**ALERT SERVICE BULLETIN**  
**Bell Helicopter** **TEXTRON**

NO. 206-07-113

**SUBJECT:** CARGO HOOK STRESS CORROSION CRACKS

Document No. 159-017-00 Rev 0

**Figure 1. Crack location**

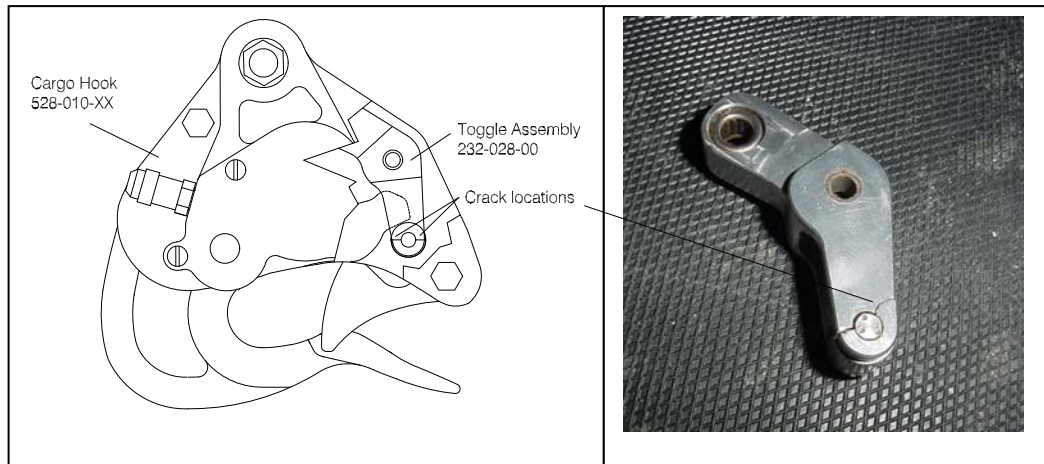
**Description:** Onboard Systems has had two reported instances of failure of the Toggle Assembly, 232-028-00. The Toggle is an internal component of Cargo Hook 528-010-XX and is a primary element of the Cargo Hook locking mechanism. Figure 1 shows the location of the failure.

**Cause:** Investigation of the failures has suggested that they were caused by Stress Corrosion Cracking (SCC). Specific mechanical, metallurgical, and corrosive conditions must be present in order for SCC to occur.

1. Residual stresses imposed by the press fit of the Load Beam Roller Pin
2. Corrosive salt water environment

1. Visual check to see if cracks are visible in the Toggle. This must be accomplished before further Cargo Hook use and daily prior to external load operations until item 2 is accomplished. If cracks are found, the Cargo Hook must be removed from service and part 2 accomplished before additional use.
2. Replace the original Toggle with a redesigned Toggle, 232-028-01, at the next scheduled overhaul, or within one year from the approval date of this bulletin, whichever comes first.

**Figure 2. Crack Locations in Toggle 232-028-00**

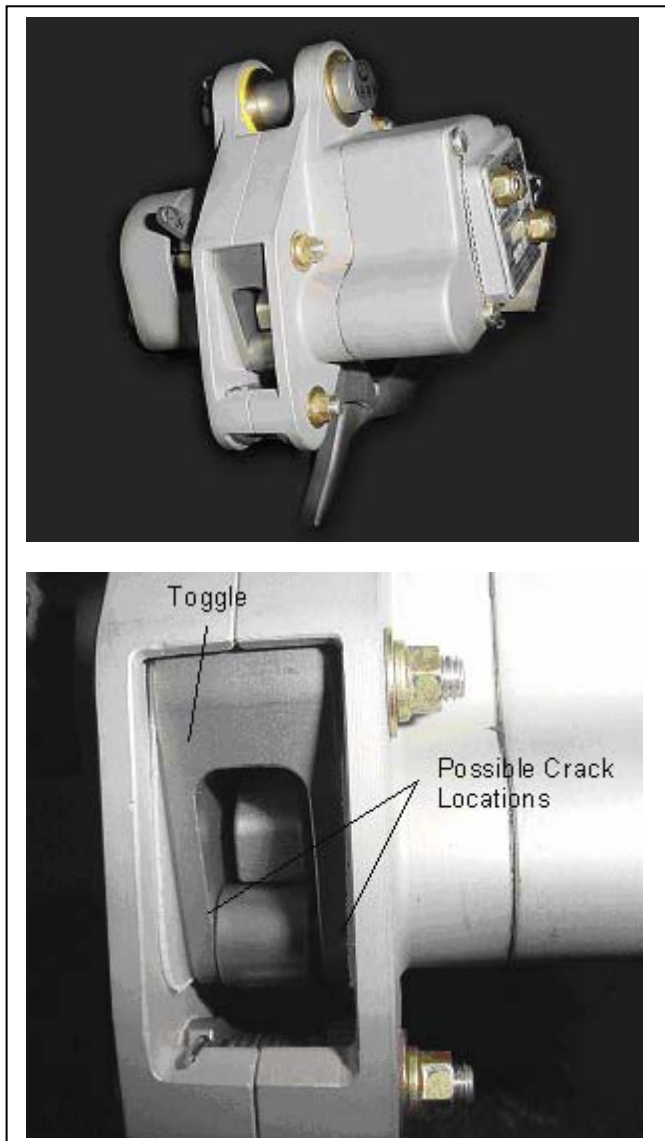
1. Visually check the Toggle for cracking or separation, as viewed in figure 2 in the assembled Cargo Hook.
2. Operate the Cargo Hook per the preflight instructions in the RFMS. If the Cargo Hook does not function properly, it must be removed from service and the part 2 instructions must be accomplished prior to use.

**Figure 4. Install New Thrust Plates.**

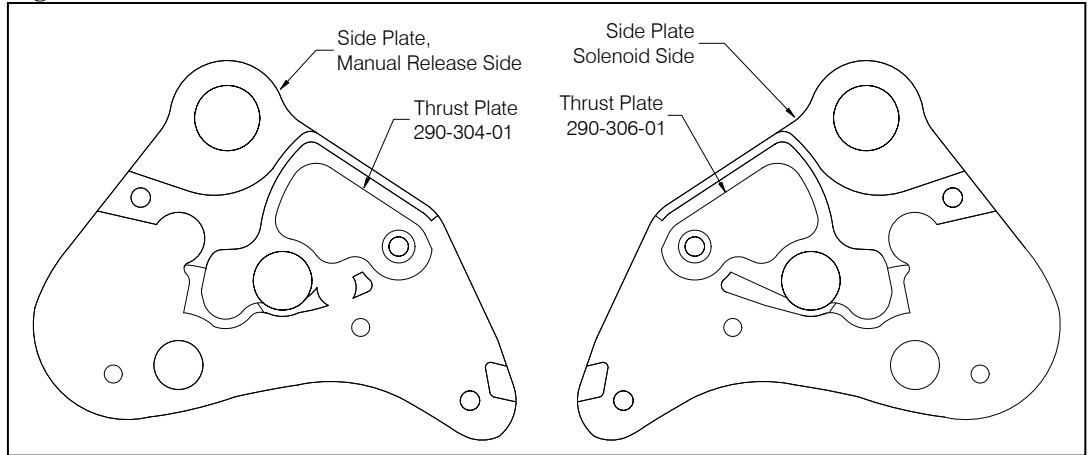
3. Remove Thrust Plates 290-306-00 from the inside of the cargo hook side plate on the solenoid side and 290-304-00 from the inside of the opposite side plate and replace with Thrust Plates 290-306-01 and 290-304-01 respectively as shown in Fig. 4\*\*.

*\*\*The Thrust Plates must be replaced or the new Toggle will not function properly.*
